2 - ADDENDUM #31
 3/2/2018
 1 - ADDENDUM #2
 2/22/2018

A NEW REMODEL PROJECT FOR:
SHERWOOD HIGH SCHOOL
 16956 SW MEINECKE ROAD
 SHERWOOD, OR

DRAWN BY: EVK
 CHECKED BY: SWM
 DATE: 1-30-18
 TITLE: PARTIAL HVAC FLOOR PLANS
 SCALE: 1/8" = 1'-0"

SHEET NO:
M-1.3
3 OF 6

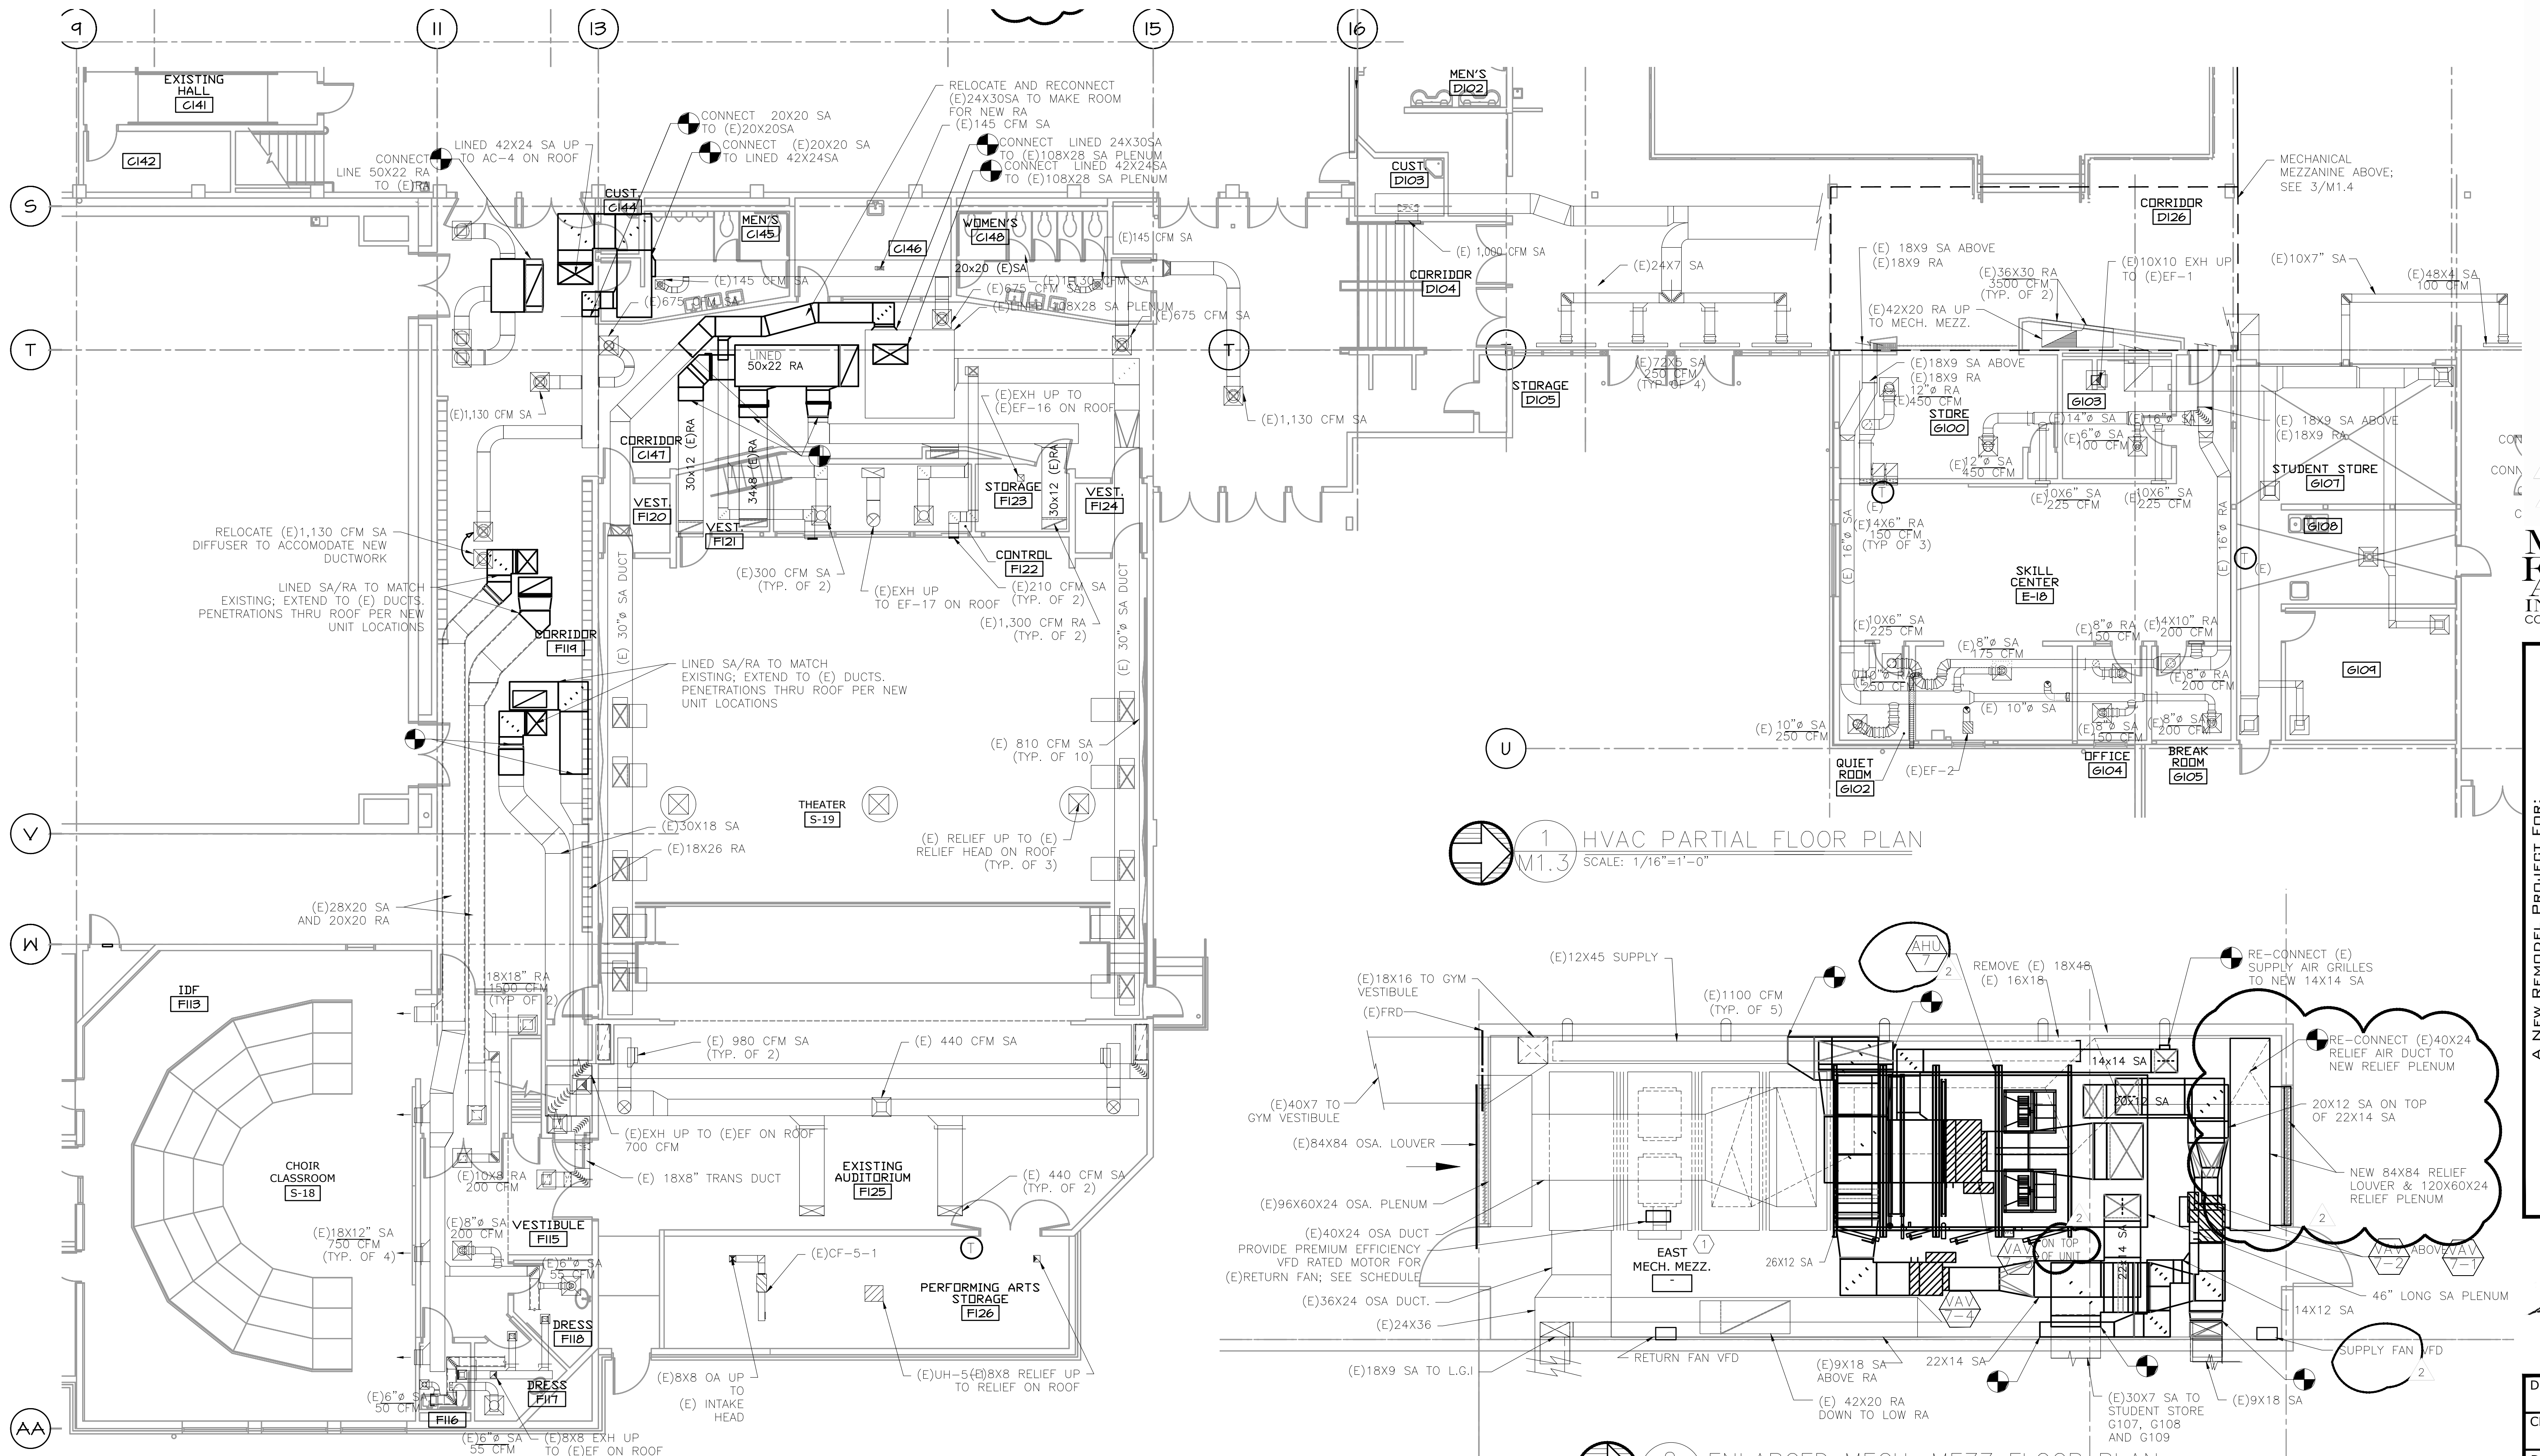
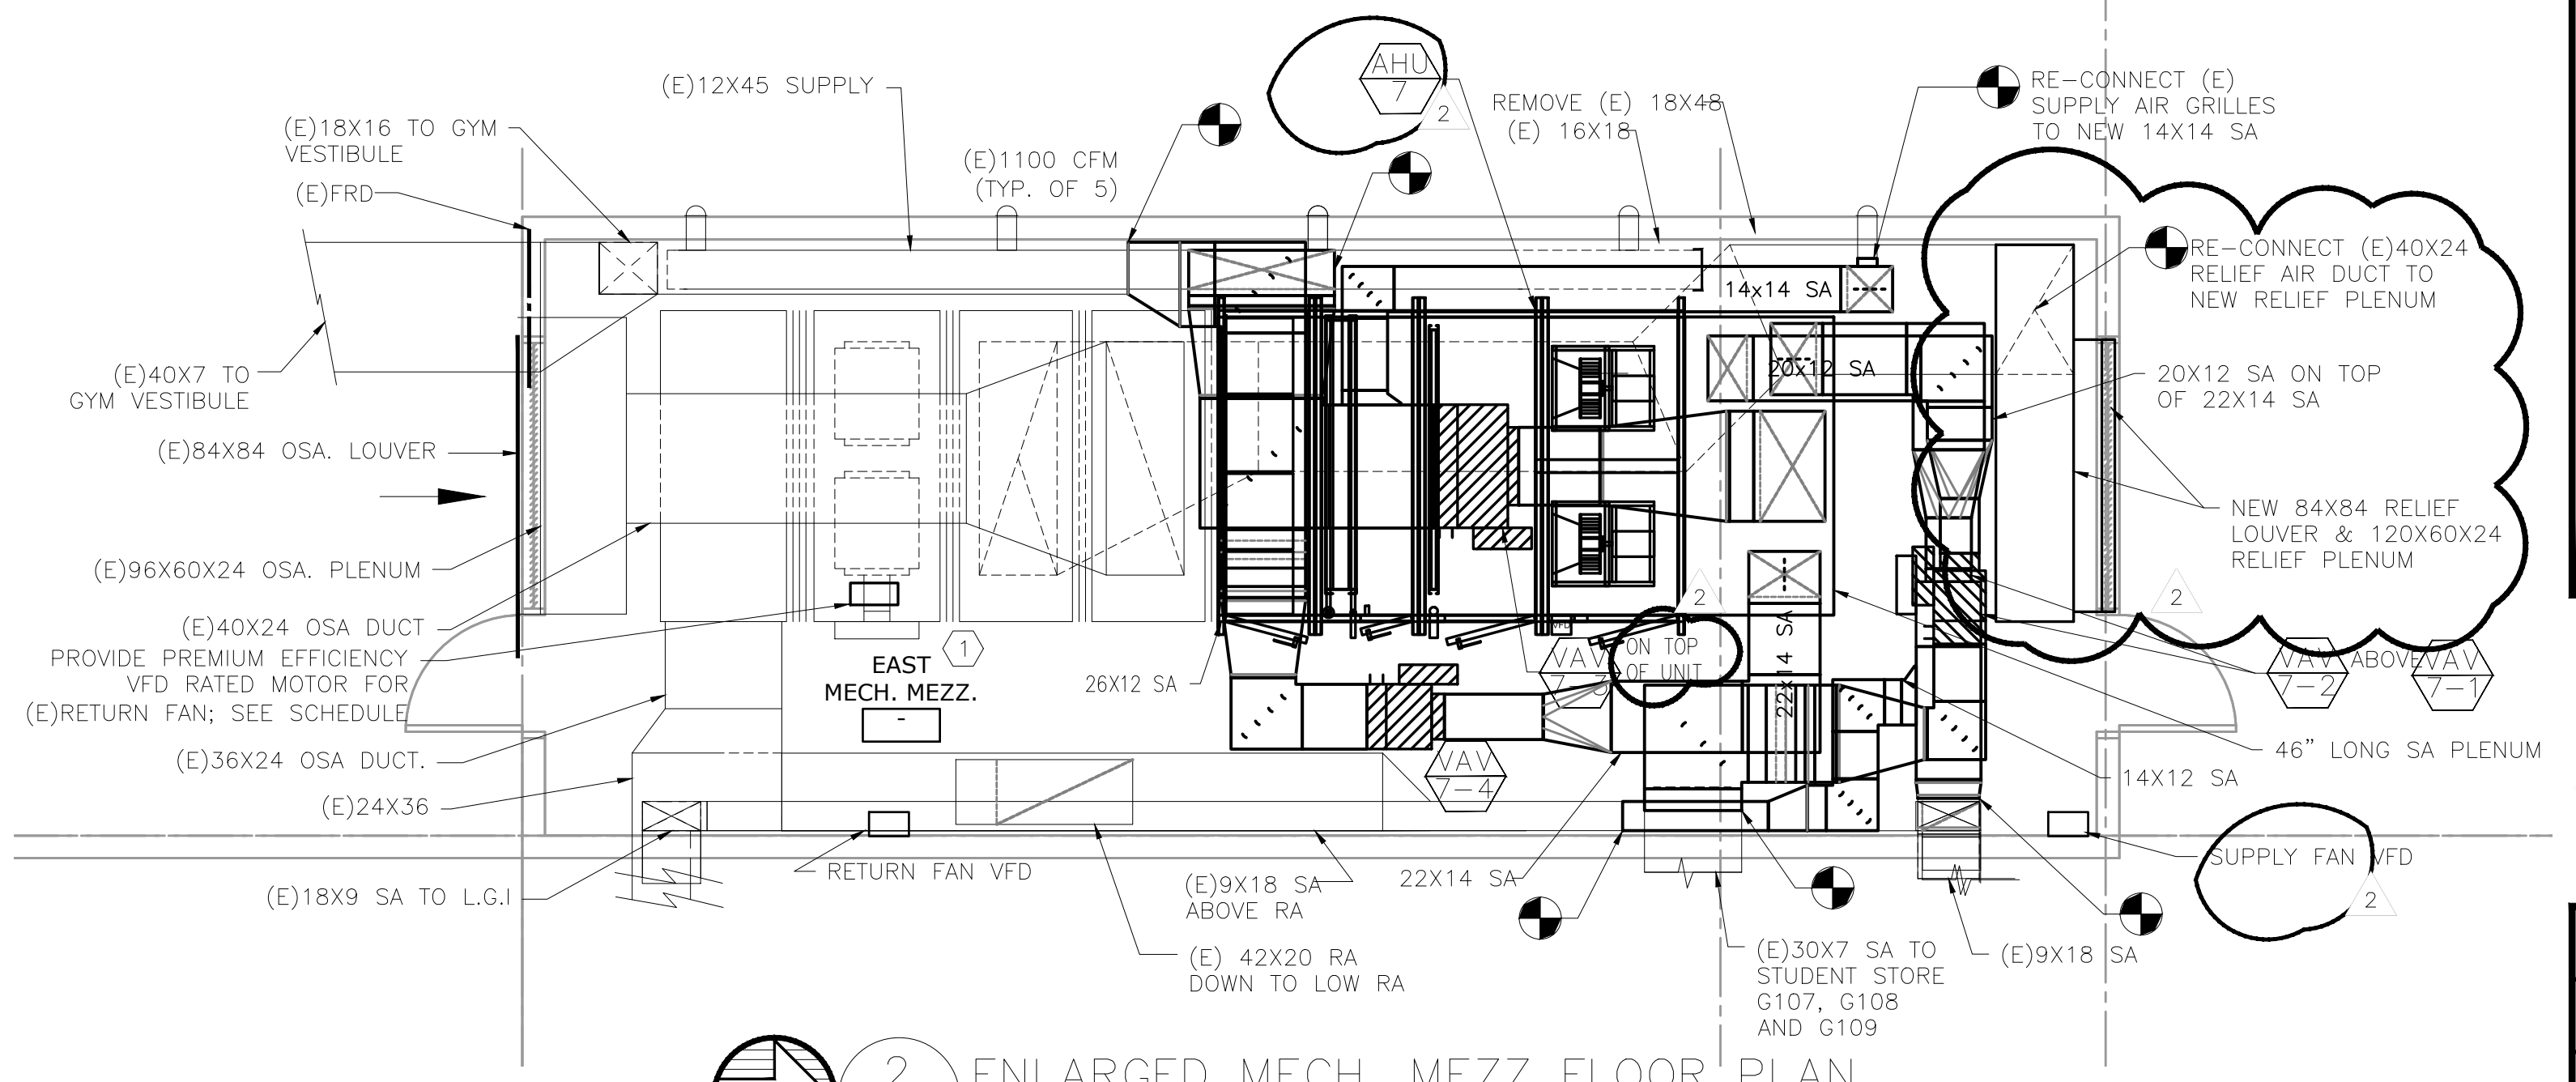
SHEET IS REVISED PER ADDENDUM #2.
